Item 4
6 Shackel Avenue, Gladesville - APL2022/0003
Section 8.3 Review of Determination of LDA2021/0278 for alterations and additions to existing residential dwelling

**City of Ryde
Local Planning Panel Report**

DA Number	APL2022/0003
Site Address	6 Shackel Avenue, Gladesville NSW 2111 Lot 19 DP 10340
Zoning	R2 Low Density Residential
Proposal	Section 8.3 Review of Determination of LDA2021/0278 for alterations and additions to existing residential dwelling.
Property Owners	Roumany and Mariam Gadalla
Applicant	Nicole Matak
Report Author	Sonya Constantinou, Consultant Planner
Lodgement Date	30 August 2021
Notification No. of Submissions	No submissions received.
Cost of Works	\$1,731,000.00
Reason for Referral to LPP	Departure from development standards – contravention of the height of buildings and floor space ratio development standards by more than 10% - <i>Schedule 1, Part 3 of Local Planning Panels Direction</i> . The former development application (LDA2021/0278) was determined by the RLPP, the review of determination decision must be conducted by the panel as per section 8.3(4) of the <i>Environmental Planning and Assessment Act 1979</i> .

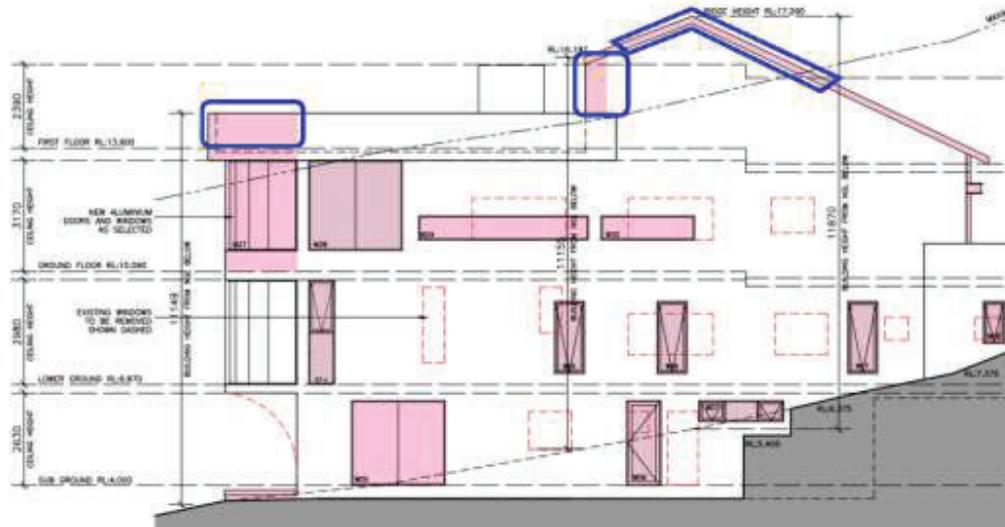
The development contravenes Clause 4.3(2) of RLEP 2014, which prescribes a maximum building height of 9.5m. The existing development has a height of 13.34m, being from the roof ridge (RL17.29) to the sub ground floor level (RL 3.95).

The proposed additions do not exceed the maximum building height of the dwelling, however, the proposed works including the provision of a planter box at first floor level and the proposed 600mm southern extension at the First Floor Level mean more of the building will contravene the height standard.

The proposed planter box results in a maximum building height of 11.65m. The increase to the First Floor results in a maximum building height of 12.25m. The proposal also seeks to replace the roof tiles with metal sheeting, which has an unchanged RL 17.290, resulting in a maximum building height of 13.34m. The applicant has submitted a Clause 4.6 request prepared by Andrew Martin Planning dated August 2022 (**Attachment 5**) to vary the development standard.

Table 3 Comparison of approved GFA, existing dwelling and proposal

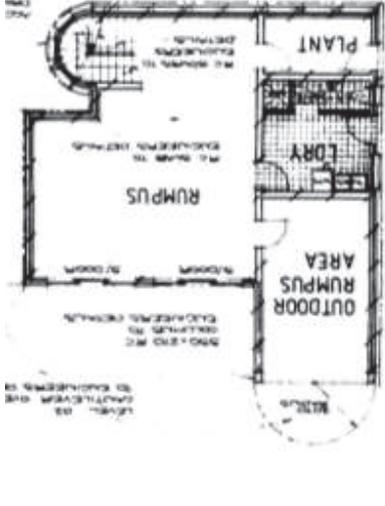
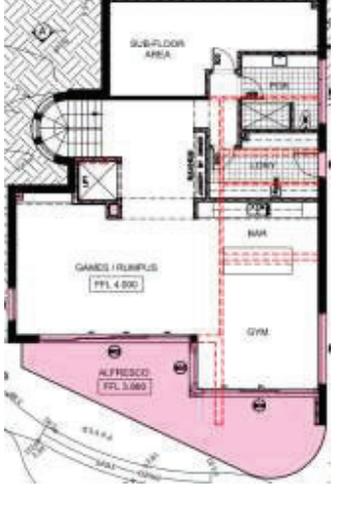
The proposed alterations and additions to the existing dwelling seek to alter the floor area of the development on each level. The comparison of the additional floor area on each floor level has been summarised in **Table 3** and the propose works are shown in pink.

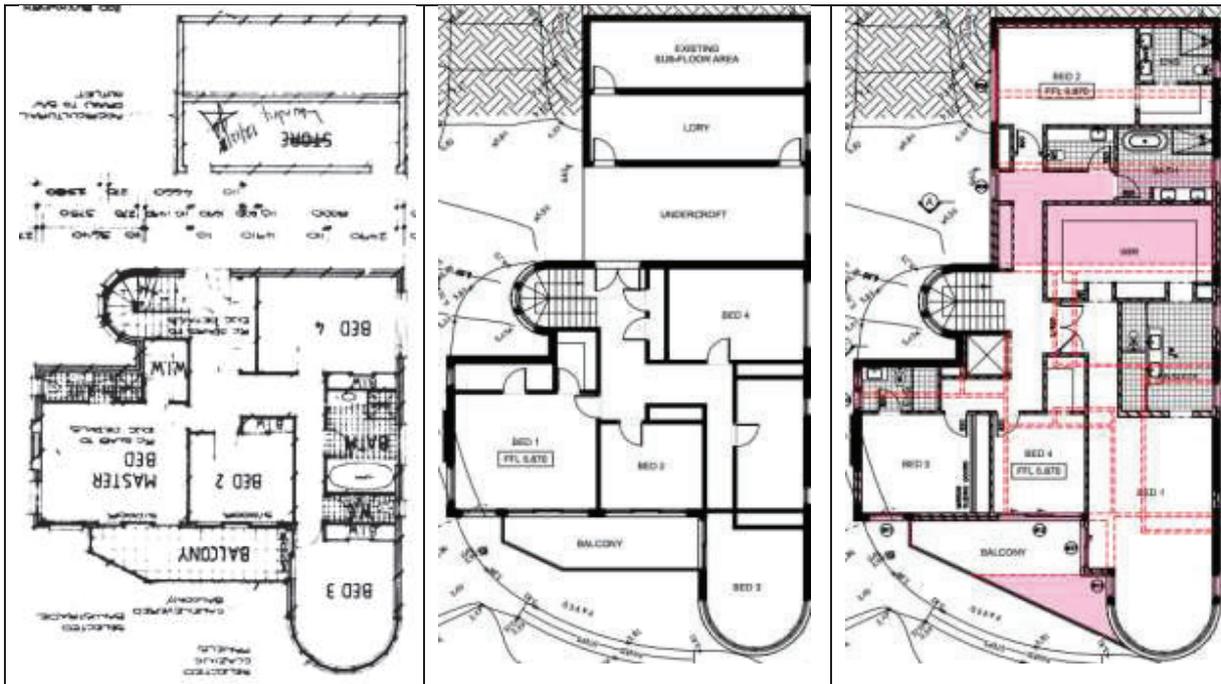
<p>Sub-Ground Floor</p> <p>The proposed development seeks to utilise aspects of the ‘existing’ subfloor area. The subfloor extends beyond the approved building floor plate. The subfloor has an area of 28m², approximately 7m² of the subfloor will contribute to GFA.</p> <p>The outdoor rumpus area has been enclosed and is currently used as a bedroom which contributes to GFA. The proposed additions also seeks to alter the width of the rumpus and the gym area and as such, alters the appearance of the development as viewed from the waterway and from the neighbouring properties.</p>

Lower Ground Floor

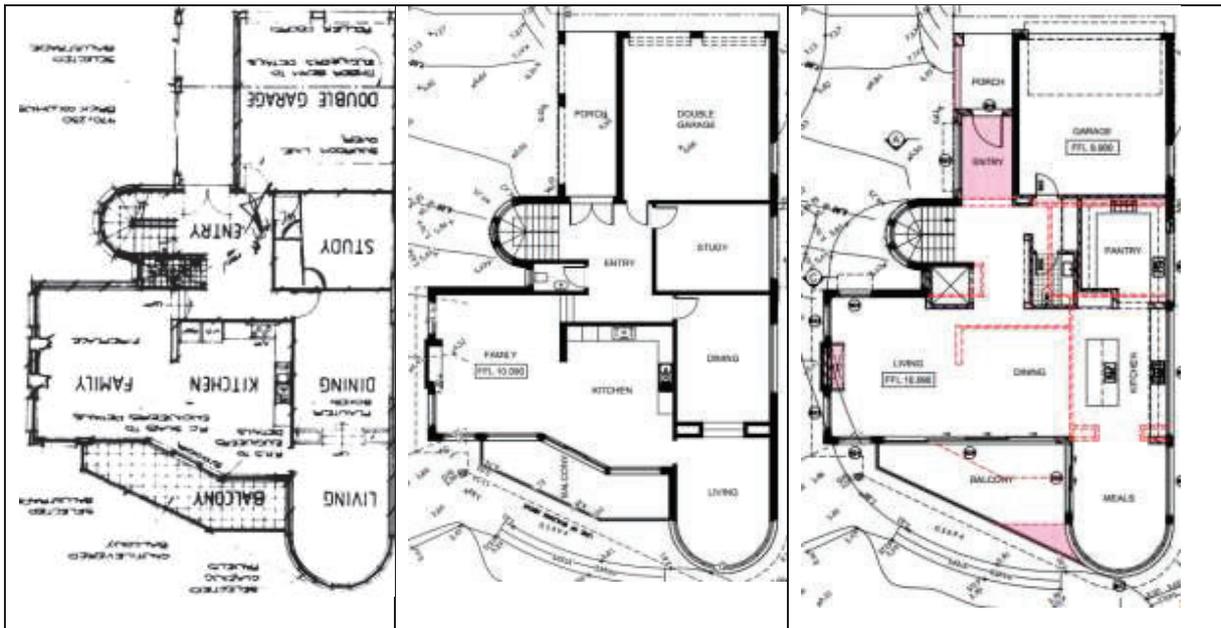
The proposed alterations and additions to this level include extending the balcony, resulting in approximately 6.5m² of additional area. Whilst this does not increase GFA, it does increase the floor plate of the building.

The proposal also seeks to enclose the undercroft area of the building as highlighted in pink, which was not marked on the approved plans and is currently able to be used for pedestrian access and parking. The area currently used for a laundry, was approved for the purpose of a store room. The area behind the laundry was not intended to be accessed but is accessible as illustrated within **Figure 14 and 15**.

The proposal seeks to extend bedroom 1 into an area currently used for the balcony (not coloured on the plans).

Ground Floor

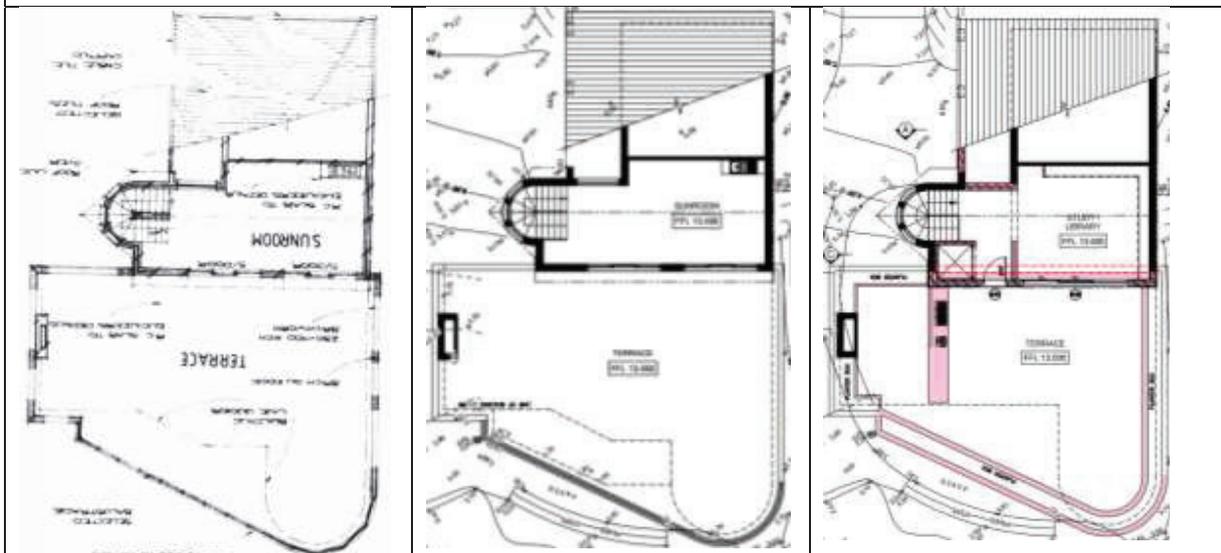
The additions on this level include the enclosure of the pedestrian entry area directly under the existing roof and next to the garage. This addition will have an area of 6m².

The proposal also seeks to increase the area of the existing balcony by approximately 7m². It is also noted, that the garage was approved with double doors which has since been replaced by a single door.

Figure 17: Section of approved undercroft area, taken from approved plans

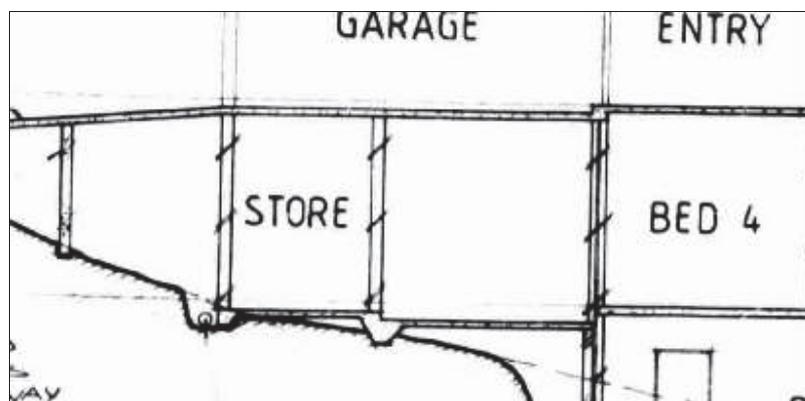
Planner's comment: **Figure 17** shows the approved area beneath the garage. The undercroft area is currently open on each end of the building; it is shown between the Store and Bed 4. The submitted plans do not include a long section north – south taken along the western portion of the building which would reflect works being undertaken. However, the western elevation (**Figure 18**) shows both works having been undertaken within the subfloor and lower ground floor areas. The proposal is not for a simple reconfiguration of the existing area, as these areas have not been lawfully approved.

Figure 18 Western elevation refer to as Elevation 2 Sheet 9

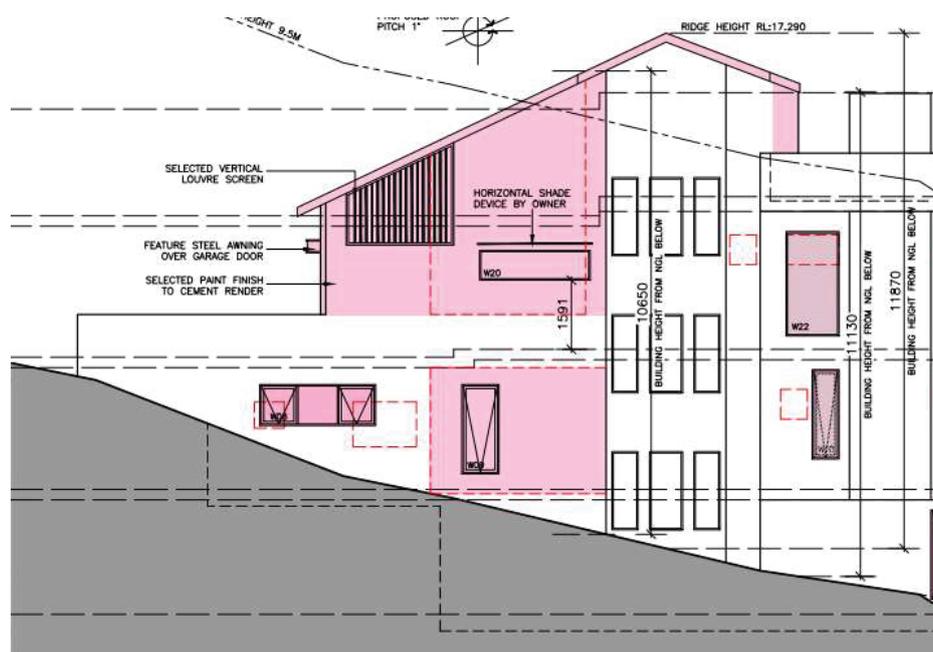
There is limited variation or articulation provided to the dwelling, and the dwelling presents discordantly within the street, with limited landscaping provided to offset this impact. The enclosure of the entry way and undercroft area when viewed from the Shackel Avenue streetscape will extend the three-storey appearance from the street as depicted within **Figure 19**. The enclosure of this space exacerbates the prominence of the dwelling.

Figure 20: Extract of eastern elevation showing the existing maximum wall plate height (13.55m) and areas of further non-compliance to both the height in storeys and the wall plate height

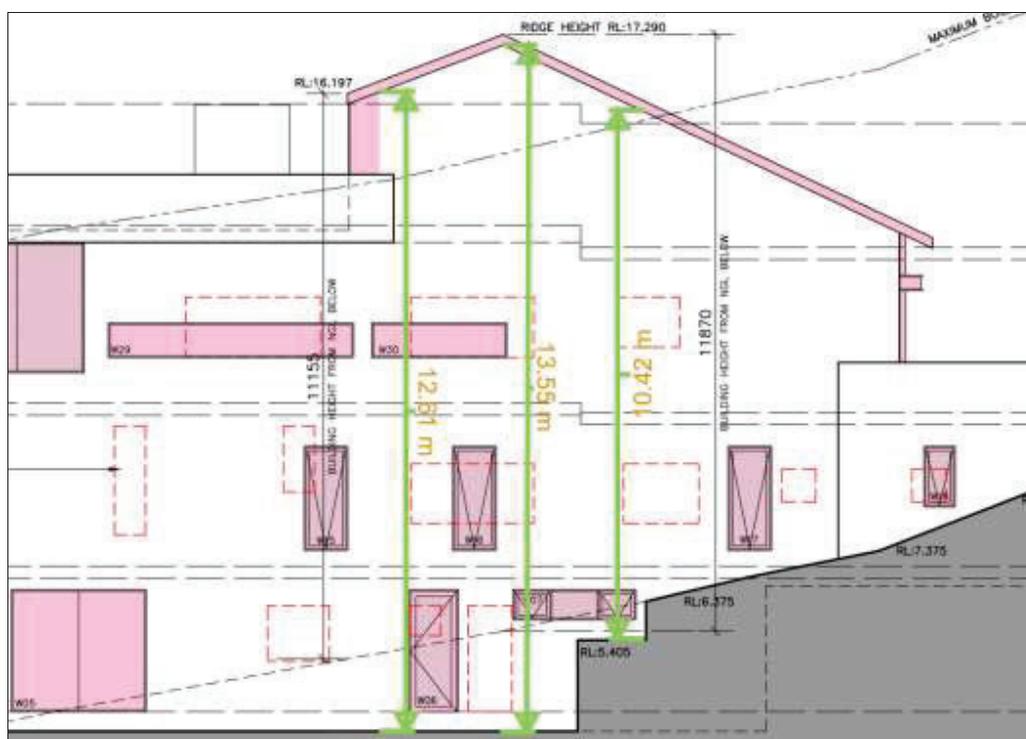
The proposal does not seek to increase either the number of storeys or the maximum wall height. However, due to the utilisation of building areas that have not been approved, adjacent to the lowest level of the development, and southward projection of new works at the uppermost level, the proposal will increase the length of the four storey portion, as well as the extent of the wall plate height non-compliance.
